Chapter 6: Safety Assessment and Management Process

6 SAFETY ASSESSMENT AND MANAGEMENT PROCESS

In accordance with FAA Safety Management System (SMS) guidelines, the FAA determined that a formal Safety Risk Management Panel (SRMP) should be formed to review ABIA's proposed airside improvements associated with the 2040 Master Plan Future Airport Layout Plan (ALP).

Exhibit 6.3-2: Proposed Airfield Layout (2037)

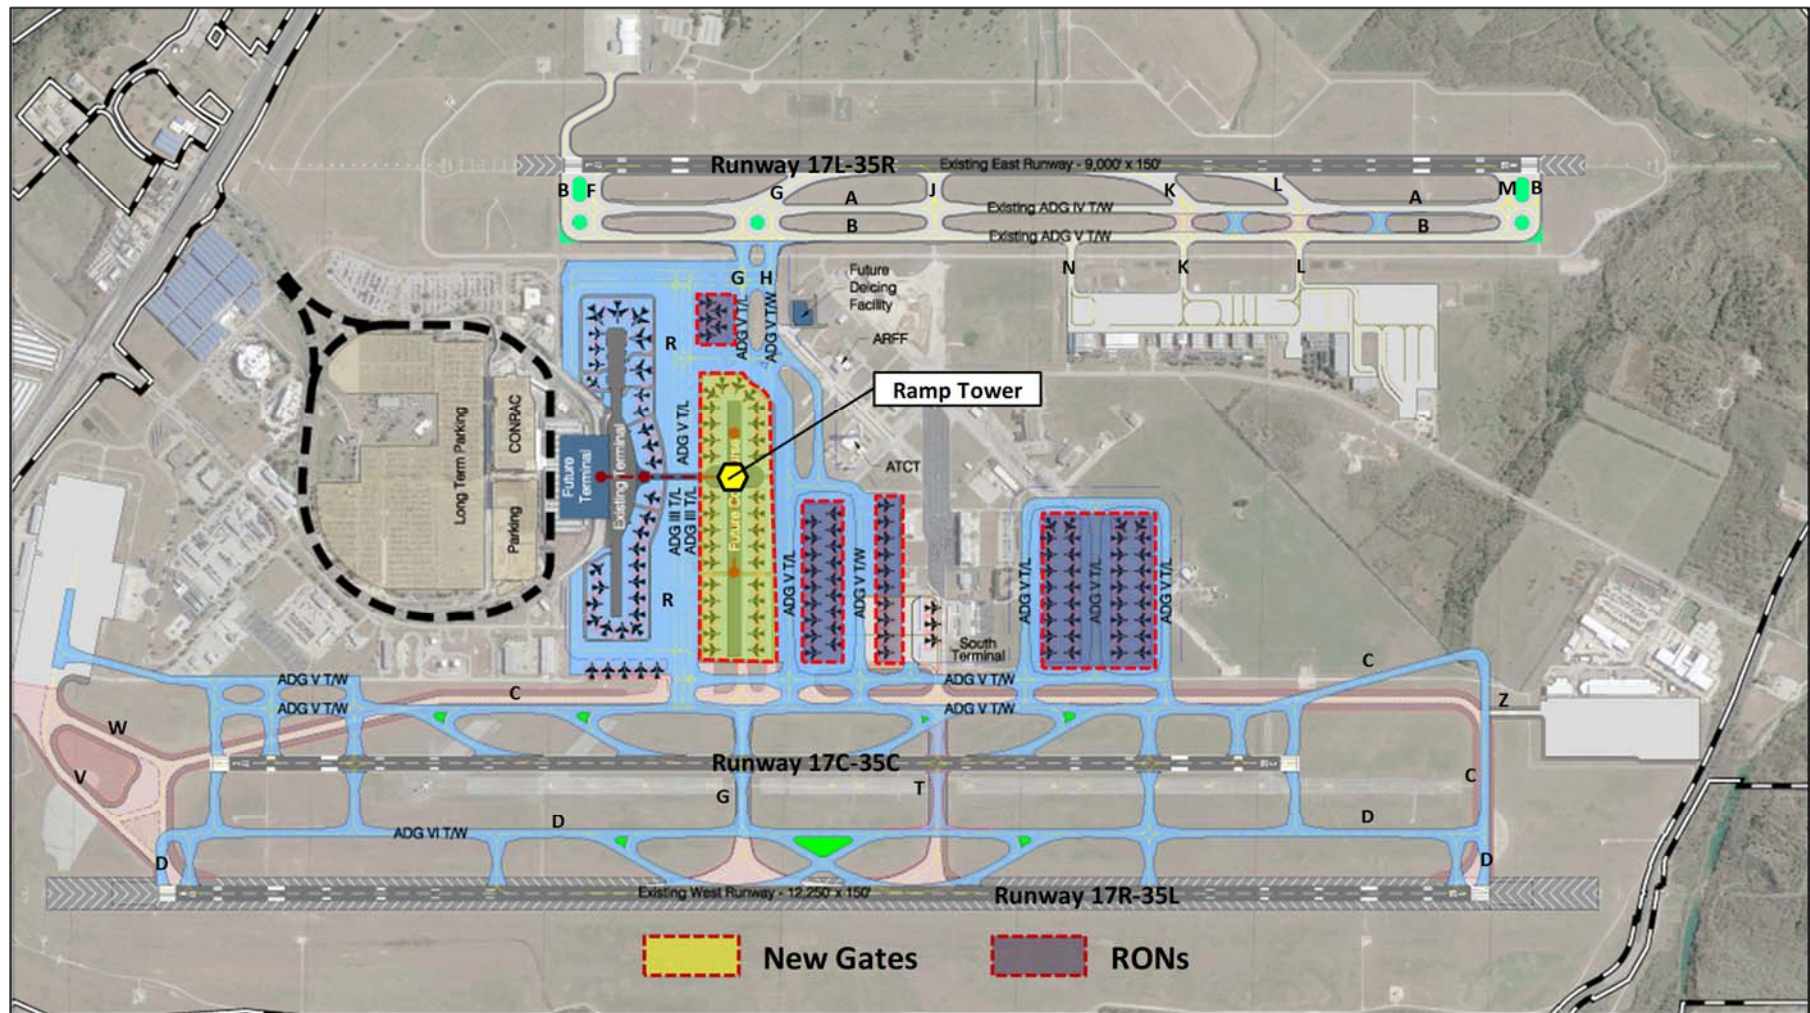
Exhibit 6.3-2 shows the proposed 2037 airfield layout for the SRMP review and comment. This proposed airfield includes the following:

6.4.4.1 Hazard #1 – Taxiway Geometry

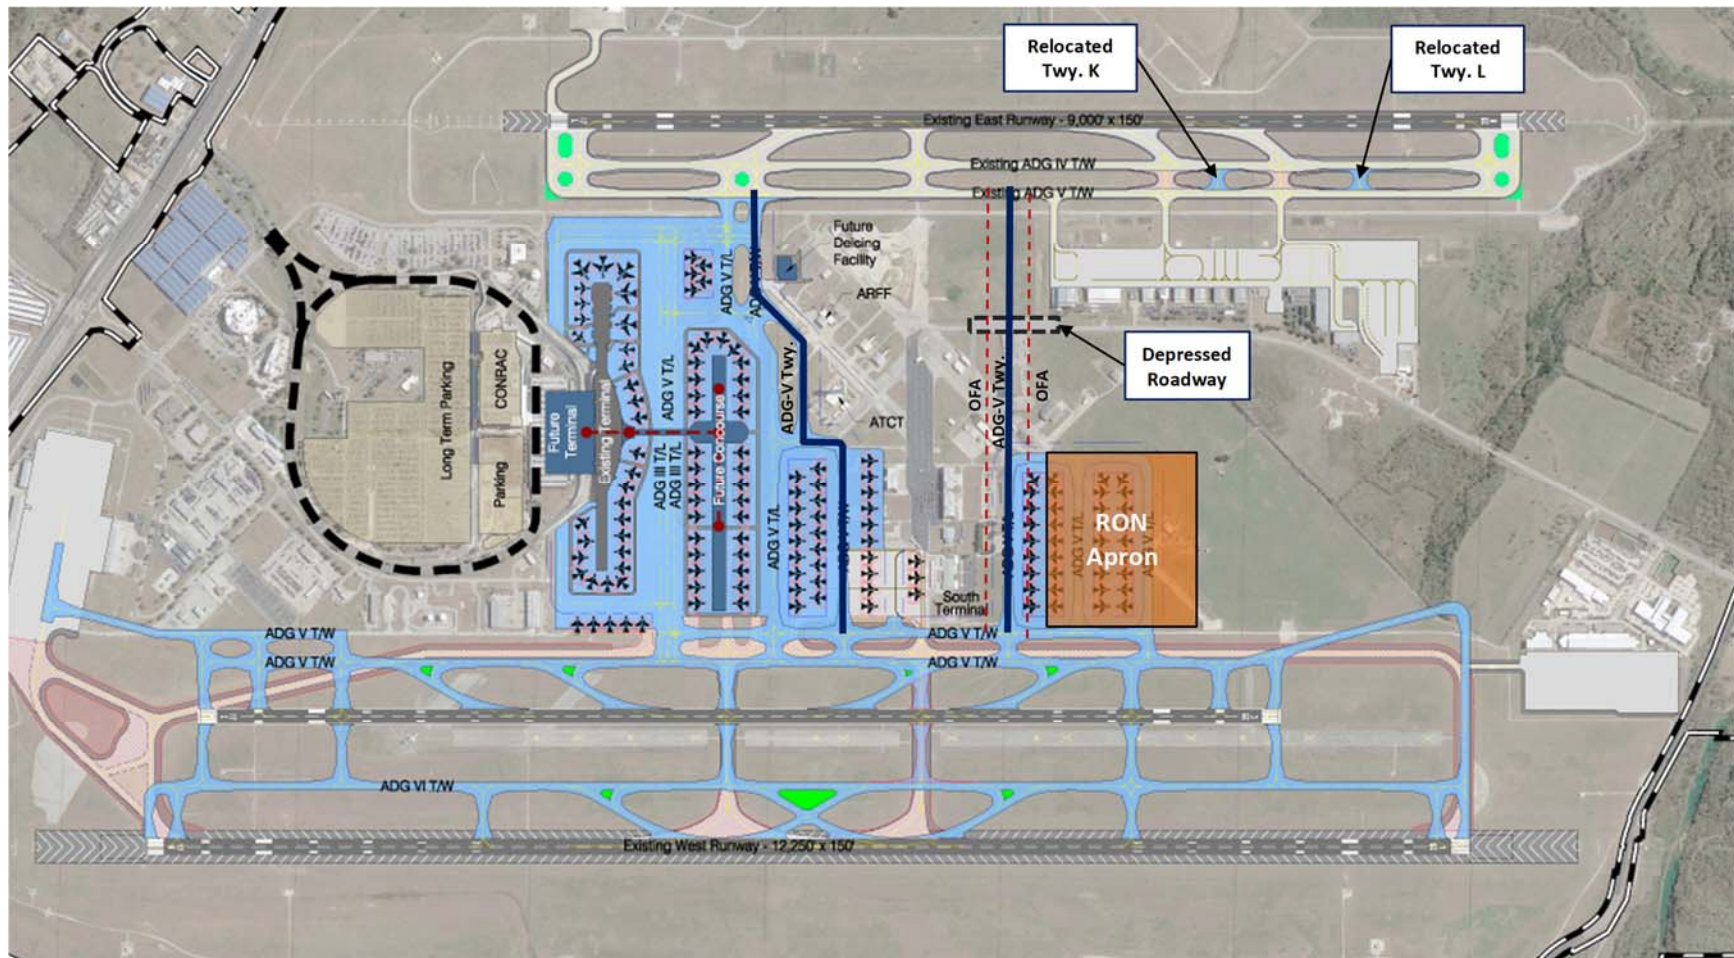
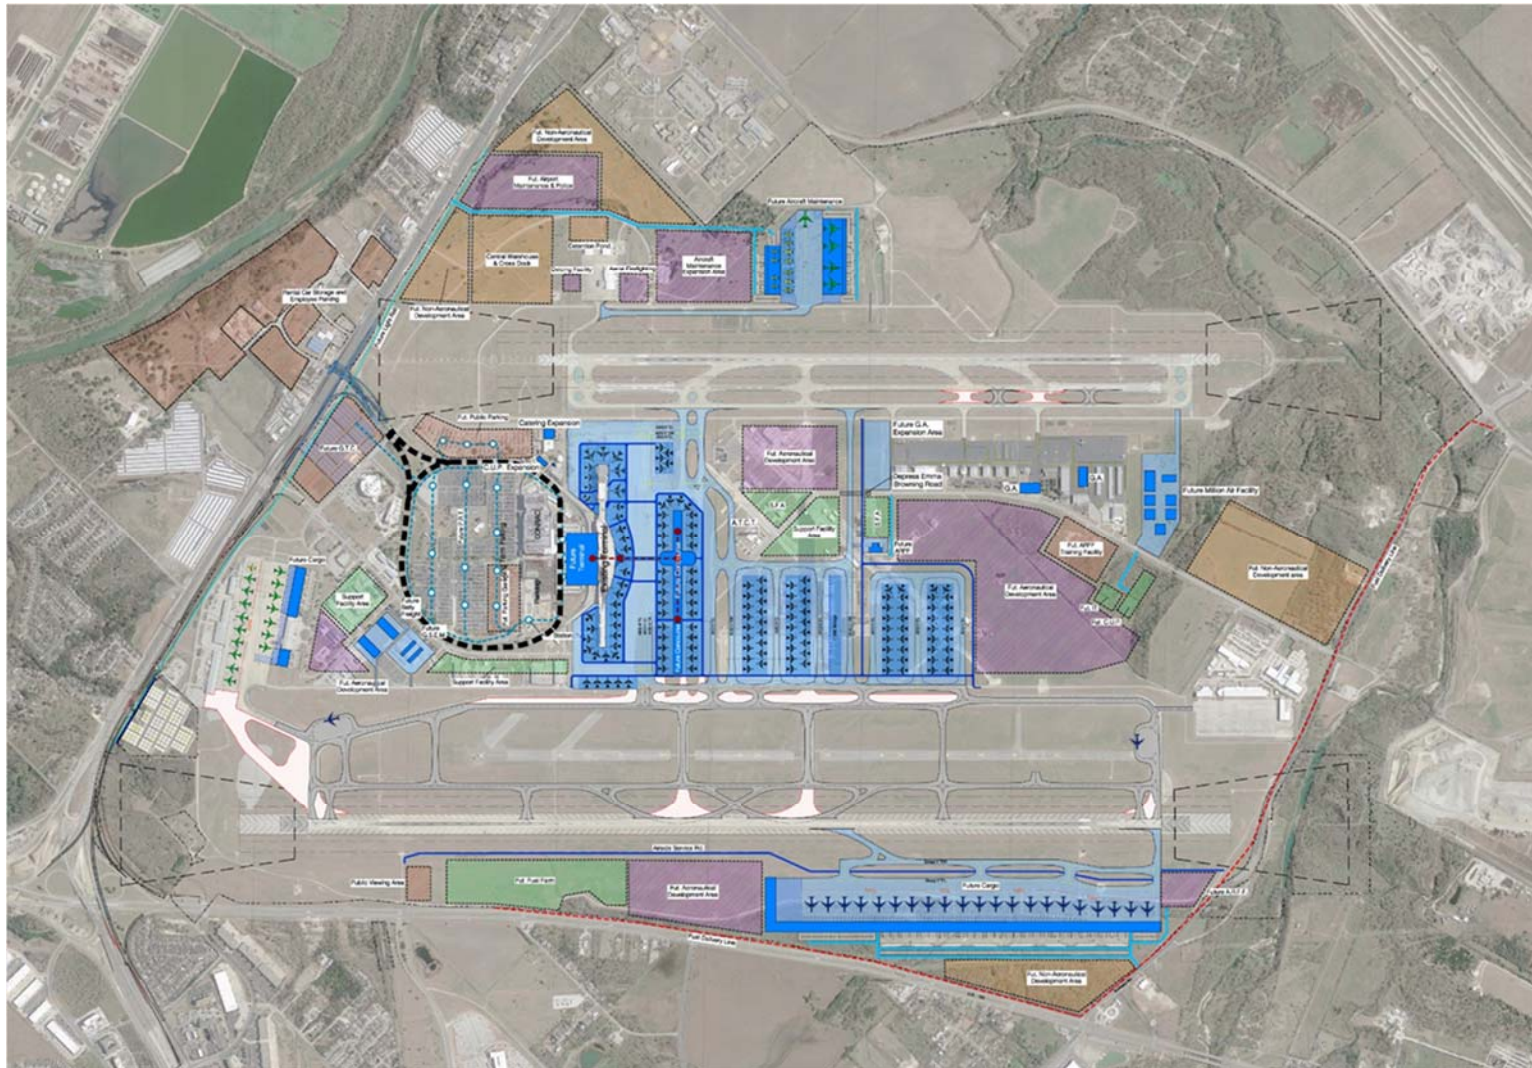
Existing Taxiways K and L have direct access from the General Aviation ramp to Runway 17L-35R which, per FAA and identified Geocode #8 “Taxiways that lead directly from an apron to a runway are not recommended. These configurations may create the false expectation of a parallel taxiway prior to the runway which could lead to confusion and runway incursions.”

Action: To resolve this hazard, the proposed solution is to modify the Taxiways K and L access into the General Aviation/Fixed Base Operator (GA/FBO) ramp area (see Proposed New Airfield Layout in **Exhibit 6.4-2**). With the applied solution, this potential hazard was eliminated.
